**URGENT FIELD SAFETY NOTICE
 MEDICAL DEVICE CORRECTION
 FSCAs 2249723-06/02/2023-010-C, 2249723-06/02/2023-011-C,
 2249723-06/02/2023-013-C & 2249723-06/02/2023-014-C
 Datascope Cardiosave Hybrid and Rescue Intra-Aortic Balloon Pumps (IABP)**

Datascope Corp., a subsidiary of Getinge is initiating a voluntary Medical Device Correction for the Cardiosave Hybrid and Cardiosave Rescue Intra-Aortic Balloon Pump (IABP) due to the following four (4) identified system conditions:

- Issue 1: Autofill Alarms
- Issue 2: Gas Loss & Gas Gain Alarms
- Issue 3: System Over-Temperature
- Issue 4: Fiber Optic Damage

Figure 2-5: Grasping the Fiber-Optic sensor connector

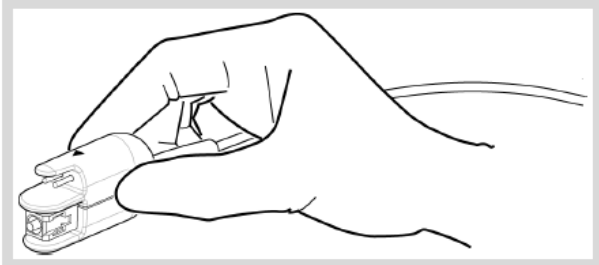
The Fiber Optic connector is designed to fit smoothly into the IAB Sensor Input. The red triangle on the top of the connector should align with the red triangle on the Cardiosave console. Inserting the Fiber Optic connector into the port without verifying the correct alignment can lead to internal damage. If difficulty is encountered when inserting the connector, verify that the connector is in the correct position and attempt to reinsert into the IAB Sensor Input.

Excessive force can cause damage to the connector and the internal fiber optic assembly of the IABP console. This may cause a disruption in the fiber optic signal acquisition resulting in an inability to acquire a fiber optic signal on the Cardiosave IABP. Following proper insertion procedures will minimize the potential for damage to the connector and a loss of signal. This conclusion is based on field observations seen through the complaints evaluation. As part of Datascope's investigation testing will be performed to confirm this observation.

Damaged Fiber Optic ports may not present as an immediate failure. There is a potential for the damage to cause an intermittent or delayed failure in the Fiber Optic connection.

1. With one hand, grasp the Fiber-Optic Sensor Connector as shown in Grasping the Fiber-Optic sensor connector, with the red triangle visible on top.

2. Remove and discard the protective cover from the Fiber-Optic IAB connector. Do not touch the exposed end of the Fiber-Optic cable.
3. With the other hand, open the protective shutter that covers the opening for the IAB Sensor Input (item 11, section 1.5.1) by rotating it to the left.
4. Insert the Fiber-Optic IAB connector into the IAB Sensor Input until it “clicks”.

Note:
Ensure that the red triangles on the Fiber-Optic IAB Sensor Connector and on the back panel are in alignment.

In step 4, when the Fiber-Optic connector is inserted into the IAB Sensor input until an audible “click” is confirmed, ensure that you are not using excessive force as that can lead to damage to the Cardiosave.
